MAINTENANCE INFORMATION

MI15-02

DATE :JANUARY 2015SECTION: 11 - REAR AXLESUBJECT :DIFFERENTIAL BREATHER REPLACEMENT

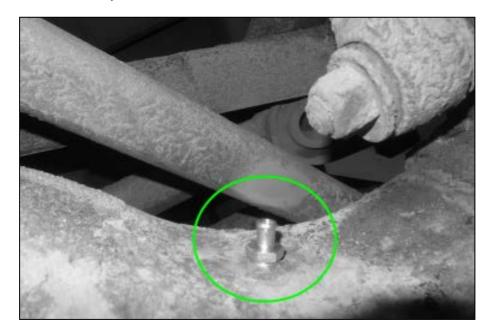
5. Remove the breather from the housing with a SAE 11/16in wrench.

6. Install the new breather body included in the kit with the same 11/16in wrench.

- 7. Use pliers to install and secure the "J" hose to the breather body making sure that the hose part is installed toward the rear of the vehicle.
